DESCRIPTIVE REPORT

Type of Survey ... Hydrographic  
Field No. ... WH-10-2-79  
Office No. ... H-9859

State ... New York  
General Locality ... New York Harbor  
Locality ... The Narrows to Norton Pt.

DESCRIPTIVE REPORT  
TO ACCOMPANY SURVEY H-9859

Bulkhead Charted 0.09 miles southeast of the Verrazano-Narrows Bridge

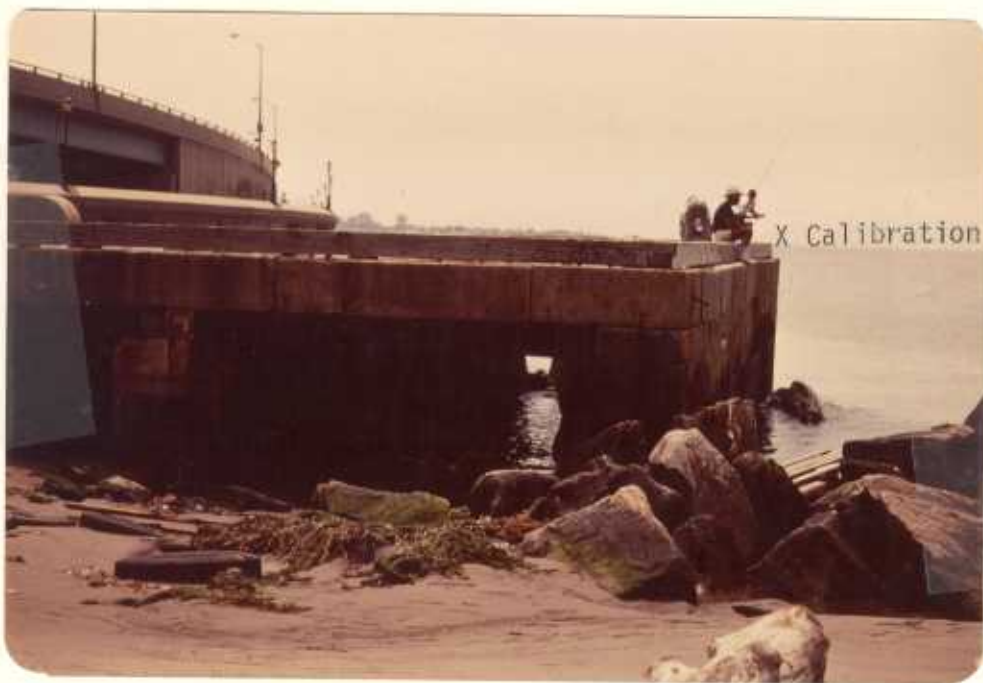
Several shoreline features along the Brooklyn/Gravesend Shoreline are incorrectly charted. A pier charted 0.09 miles southeast of the Verrazano-Narrows Bridge at  $40^{\circ}36'28''\text{N}$ ,  $074^{\circ}02'09''\text{W}$  is incorrectly charted. A three point sextant fix was obtained on the southern edge of the pier and its actual GP was found to be  $40^{\circ}36'29.43''\text{N}$ ,  $074^{\circ}02'07.53''\text{W}$ . The configuration of this pier is not the same as it is charted. See explanation on page 14. Pictures of this pier can be found in the Appendix under List of Stations. *See sections 2, 4, & 7 of the Verification Report.*
